## Lower Air Channel

Fig. 8

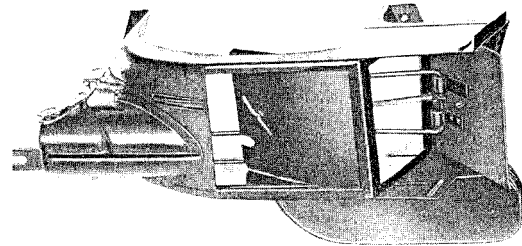
In order to increase the flow of cooling air of the 1600S-90 engine, a specially designed lower air channel having two outlet flaps and an intake funnel for the fan housing have been incorporated in the cooling system.
